APPLICATION NO.	FILING DATE	FIRST NAMED INVENTOR	ATTORNEY DOCKET NO.	CONFIRMATION NO.
10/668,746	09/23/2003	Jin Shenghao	15865.1a.1	1790

<b>Office Action Summary</b>	<b>Application No.</b> 10/668,746	<b>Applicant(s)</b> SHENGHAO ET AL.	
	<b>Examiner</b> Janet M. Wilkens	<b>Art Unit</b> 3637

# Fig-4

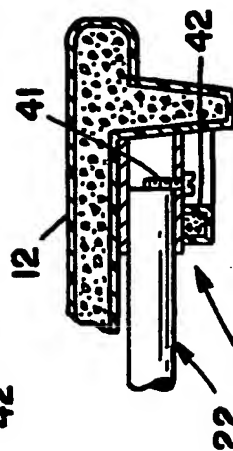
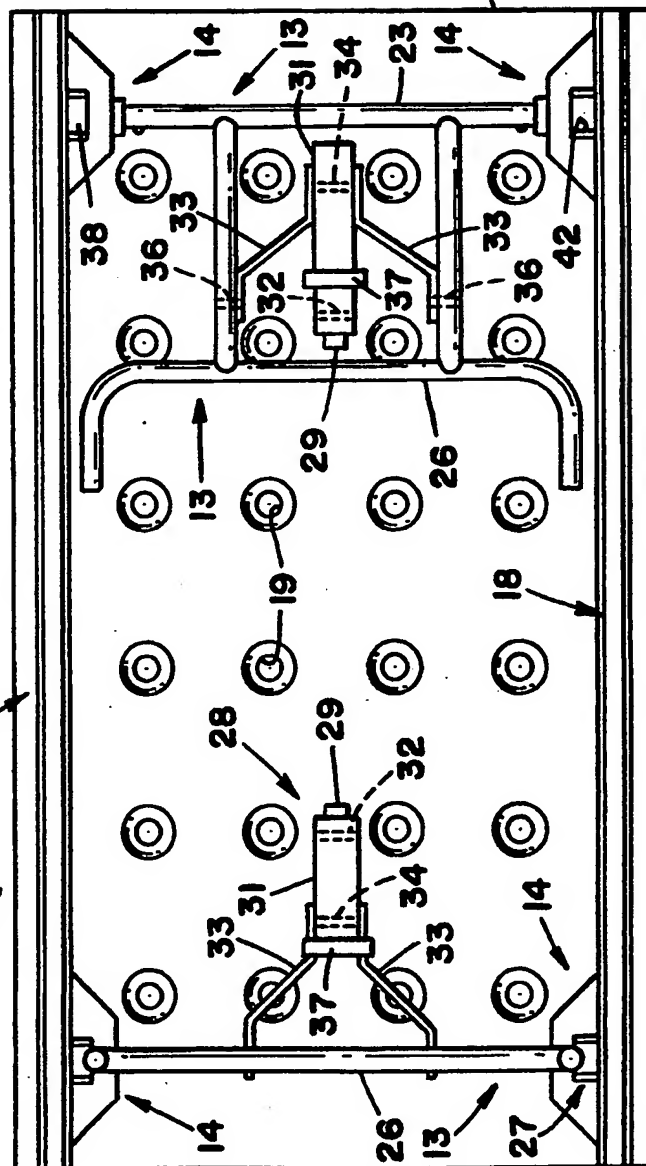
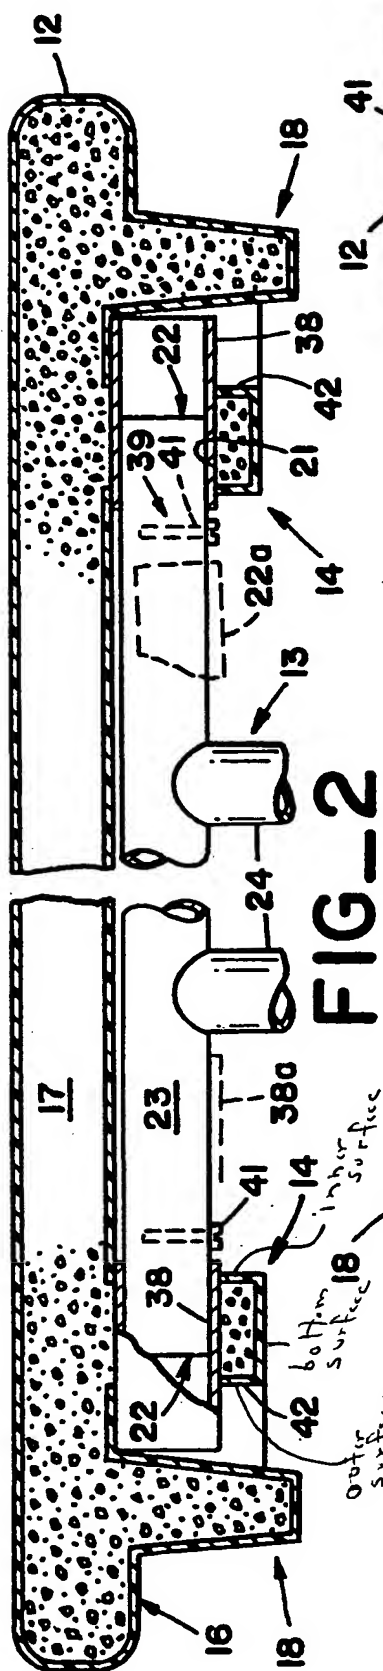
Claims 1, 4, 9, 13 and 18 are rejected under 35 U.S.C. 102(b) as being anticipated by Dutro et al (5,394,808). Dutro et al teaches a table (Fig. 1; see Attachment A) comprising: a plastic molded table top (12) having a lip (14) with interior, outer and bottom surfaces, a first connecting aperture (inner opening) located in the interior surface and a second connecting aperture (outer opening) located in the exterior surface; a sleeve (38); a first table leg (24); and a first cross pole (23) attached to a first end of the table leg and disposed in the first and second connecting apertures. Since Dutro teaches all of the structural limitations found in the method claims; the method steps would inherently be provided for.
